ENG-PUDSP21001-R1-PDR-Redlines.pdf Markup Summary

1 (1)		
PUDSP-21-001	Subject: SW - Text Box Page Index: 1 Date: 2/2/2021 11:52:27 AM Author: GReese Color: ■ Layer: Space: Page Label: 1	PUDSP-21-001
2 (2)		
	Subject: Cloud+ Page Index: 2 Date: 2/18/2021 5:21:47 PM Author: dsdrice Color: Layer: Space: Page Label: 2	Only use County signature blocks
510 Date pincering comply with all of the requerements specified in this writes that the dramage functions for Witting are presented in the proof. Understand that the Cry chainman further dramand and we sentified her ner		
3 (1)		
The second secon	Subject: Callout Page Index: 3 Date: 2/18/2021 5:23:32 PM Author: dsdrice Color: Layer: Space: Page Label: 3	Tract I and
6 (2)		
2	Subject: Highlight Page Index: 6 Date: 2/18/2021 6:31:53 PM Author: dsdrice Color: Layer: Space: Page Label: 6

50 (14)

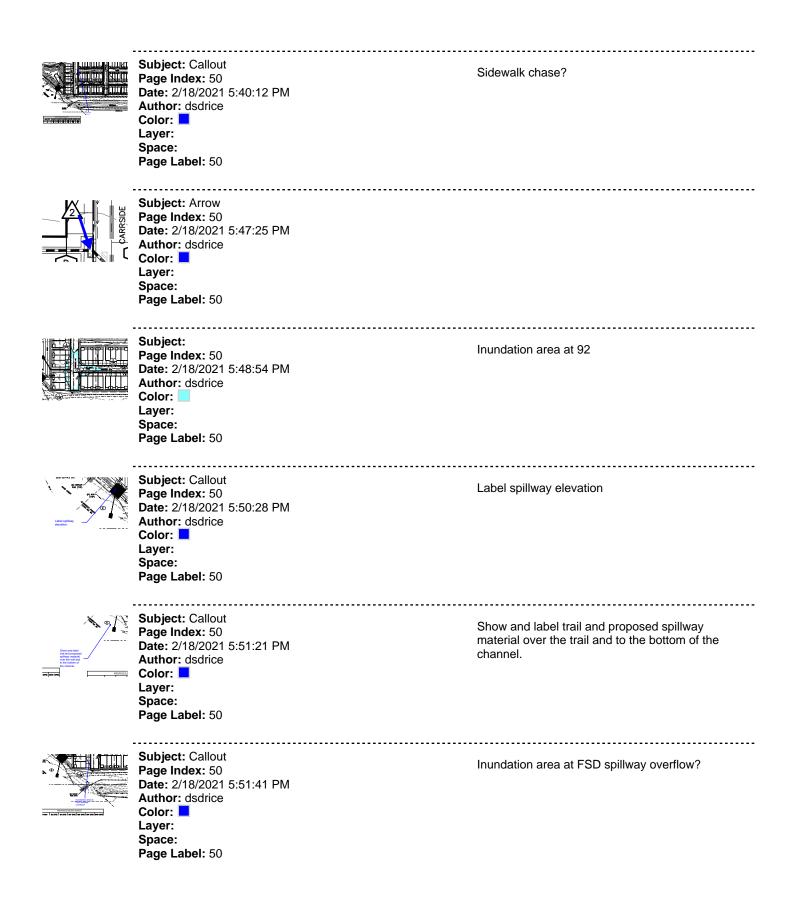
label ditch

-----Subject: Arrow Page Index: 50 Date: 2/18/2021 3:48:16 PM Author: dsdrice Color: Layer: Space: Page Label: 50 -----. Subject: Callout Show and label manhole Page Index: 50 Date: 2/18/2021 3:49:00 PM Author: dsdrice Color: Layer: Space: Page Label: 50 Subject: Callout Show and label all easements Page Index: 50 Date: 2/18/2021 3:49:47 PM Author: dsdrice Color: Layer: Space: Page Label: 50 Subject: Callout Clearly show all maintenance access roads Page Index: 50 required. Date: 2/18/2021 4:00:09 PM Author: dsdrice Color: 📘 Layer: Space: Page Label: 50 Subject: Callout A standard forebay design is required. Page Index: 50 Date: 2/18/2021 4:00:28 PM Author: dsdrice Color: Laver: Space: Page Label: 50 Subject: Callout Label Page Index: 50 Date: 2/18/2021 5:37:46 PM Author: dsdrice Color: Layer: Space:

Provide a table with pond attributes (outlet and spillway elevations, water depths and volumes at WQCV, EURV, 10- and 100-year storms, etc.).
